Re: Florida Power & Light Company  
Proposed Turkey Point Units 6 and 7  
Docket Nos. 52-040 and 52-041  
Response to NRC Request for Additional Information Letter No. 085 (eRAI 7950)  
SRP Section 02.05.01 – Basic Geologic and Seismic Information

**NRC RAI Letter No. PTN-RAI-LTR-081**

**NRC RAI Number: 02.05.01-38 (eRAI 7950)**

**NRC RAI Number: 02.05.01-39 (eRAI 7950)**

**Figure 1: Seismic Reflection Profile of Reverse Faults from Cunningham (2015)**

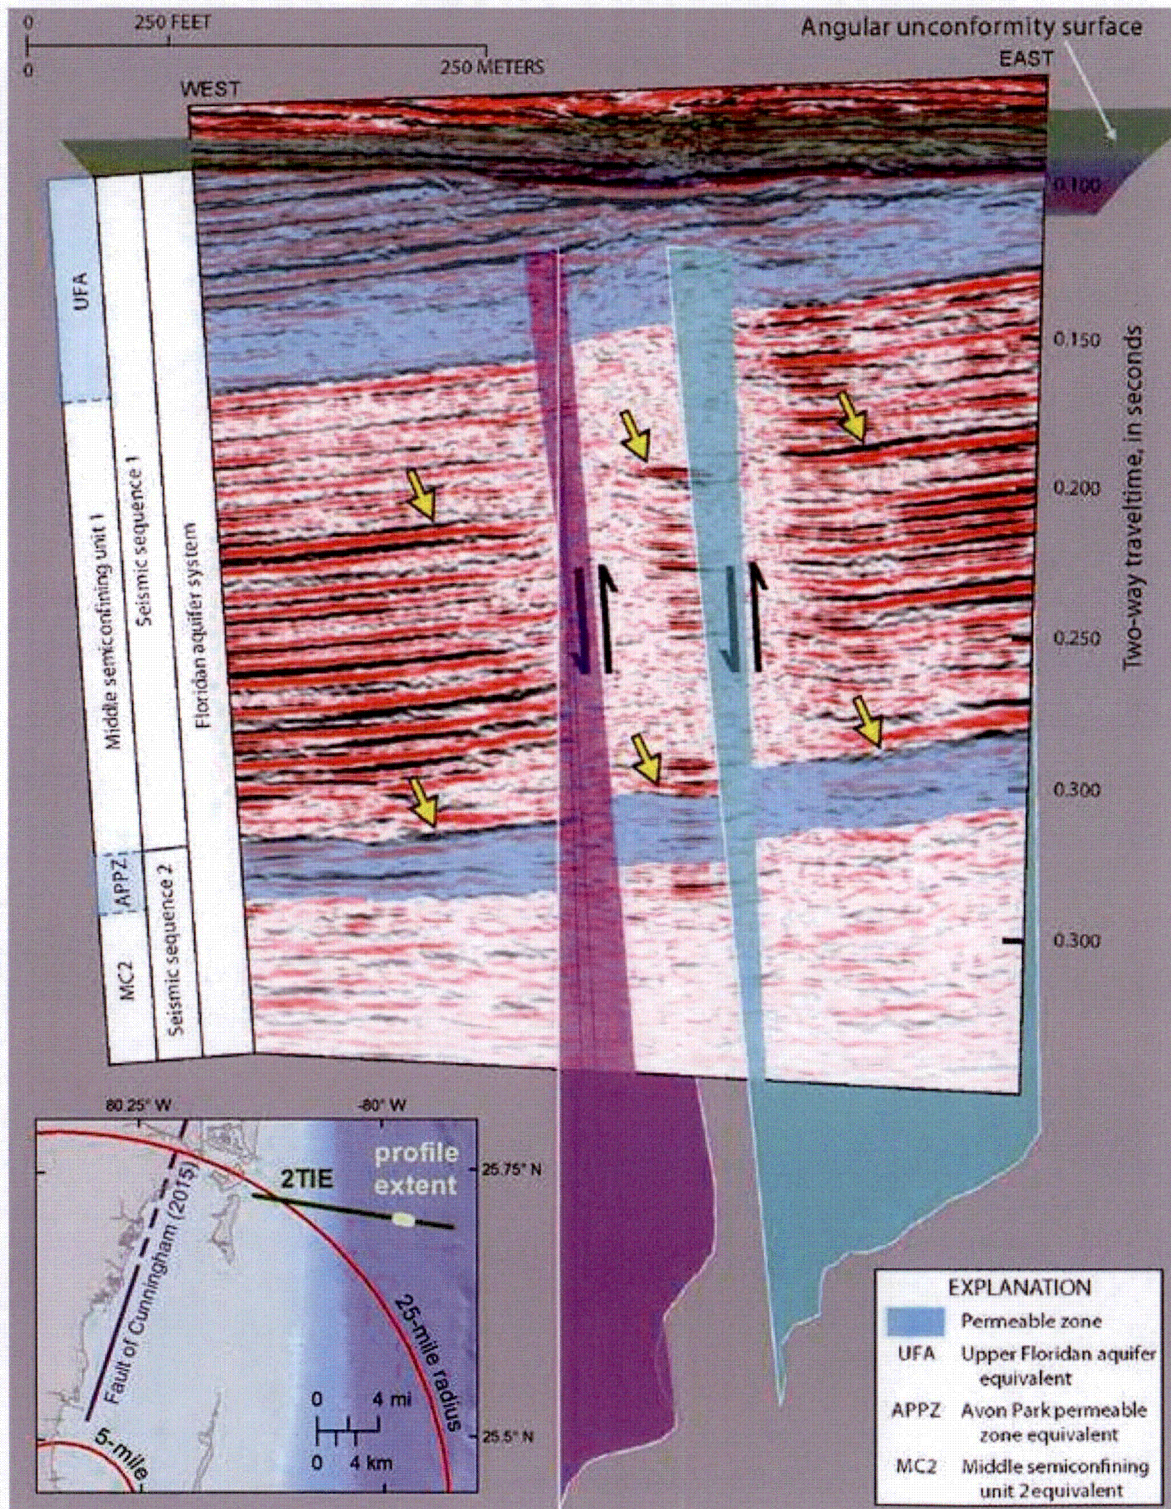
In eRAI 7804, Question 2.5.1-36, staff asked you to provide a discussion of a fault identified by seismic reflection data and located in Biscayne Bay (Cunningham et al 2012) that was not previously included in the FSAR. In your response, you cite a new publication (Cunningham, 2015). Staff examined that report, which identifies an additional, potentially geologically young, tectonic feature, located east of Miami, on the Miami Terrace, about 30 miles from TPNPP, which is not described in the TPNPP FSAR. Figure 14 in Cunningham 2015 clearly shows a tectonic anticline with uplifted truncated seismic reflections assigned to the top of the lower Arcadia Formation. Horizontal buried wave cut terraces on the flank of the anticline indicate uplift and erosion of the lower Arcadia Formation followed by deposition of late Pliocene or early Pleistocene-age sediments. Cunningham suggests that this compression, uplift and reverse faulting is consistent with compressional stresses in the Cuban fold and thrust belt and cites Masaferro and others, 1999. The author also suggests that this compression event is consistent with the timing of tectonic movement of the Santaren anticline.

- a) In support of 10 CFR 100.23, please provide a discussion of this tectonic feature with respect to TPNPP and integrate into the regional tectonic setting for the TPNPP COLA.
- b) Discuss how this feature might affect the PSHA at TPNPP in light of sensitivity analyses completed for the Santaren Anticline (~170 miles from TP) and the sensitivity analyses completed for the Walker's Cay fault (~200 mile from TP).

Based on recently acquired offshore seismic reflection profiles, Cunningham et al. (2012) (Reference 1) and Cunningham (2015) (Reference 2) identify a group of 5 reverse faults (only two of which are shown as purple and cyan planes on their figures for clarity) (Figure 1) and an anticline (Figure 2) beneath the offshore Miami Terrace, approximately 30 miles (45 kilometers) northeast of the Turkey Point Units 6 & 7 site. These structures deform strata of the Upper Floridan Aquifer (UFA), which contains the upper portion of the middle Eocene Avon Park Formation, the Ocala and Suwannee Limestones (where present) and the Oligocene or early Miocene lower Arcadia Formation (Reference 2).

The two primary reverse faults, shown as purple and cyan on Figure 1, offset seismic reflections in middle Eocene-age strata of the lower portion of the UFA system in an east-side-up sense (Reference 2). Yellow arrows point to seismic-reflections indicating structural offset between fault blocks (Reference 2). Cunningham (Reference 2) omits the three other faults for clarity on Figure 1. Because the reverse faults were only imaged at one location, no information about the strike or extent of these faults is currently available. Cunningham et al. (2012) (Reference 1) indicate that the timing of reverse fault movement is not well constrained, but reports that the most-recent movement probably occurred sometime during the late Eocene to early Pliocene Epochs, whereas Cunningham (2015) (Reference 2) indicates that the reverse-fault movement occurred sometime within the Oligocene to early Pleistocene (Reference 2).

Cunningham (2015) (Reference 2) suggests that the reverse faults on the offshore Miami Terrace and the anticline observed on the 2TIE seismic profile formed coevally. Cunningham concludes that the relations observed in the seismic-reflection profiles point to contractional uplift and reverse faulting sometime during the Oligocene to early Pleistocene (Reference 2). The timing of this uplift and reverse faulting in southeastern Florida postdates intense northerly directed thrust movement in nearby Cuba during the early to middle Eocene (Pardo, 2009) (FSAR Reference 2.5.1-439), but may coincide with later possible contractional deformation episodes recorded in the Bahamian foreland of the Cuban fold and thrust belt. For example, reverse-fault movement

In Reference 1, Cunningham et al. (2012) indicate that the timing of reverse fault movement is not well constrained, but probably occurred during the late Eocene to early Pliocene Epochs (i.e., >3.6 Ma). Cunningham (2015) (Reference 2) reports that anticlinal uplift and reverse faulting occurred sometime within the Oligocene to early Pleistocene (i.e., >1.8 Ma). Because the uppermost deformed (faulted or folded) unit observed in seismic profiles beneath the Miami Terrace is the Oligocene to Miocene Arcadia Formation, and undeformed late Pliocene or early Pleistocene sediments (>1.8 Ma) overlie the reverse faults and anticline identified in the seismic lines, the structures are not considered to be capable tectonic features. Within approximately 25 kilometers of Cunningham's (2015) (Reference 2) reverse faults and fold there is only one earthquake in the project Phase 1 earthquake catalog, including dependent events. This Emb 2.70 earthquake occurred on December 22, 1945 and is located approximately 10 km north-northeast of the fold and 10 km north-northwest of the reverse faults. Thus,

there does not appear to be an association of seismicity with these structures. Moreover, there are no nearby potential Quaternary tectonic structures or capable faults (see FSAR Figure 2.5.1-205). Therefore, the reverse faults and fold reported by Cunningham et al. (2012) and Cunningham (2015) (References 1 and 2) are not capable tectonic sources and would not affect, and should not be included in, the PSHA for the Turkey Point Units 6 & 7 site.
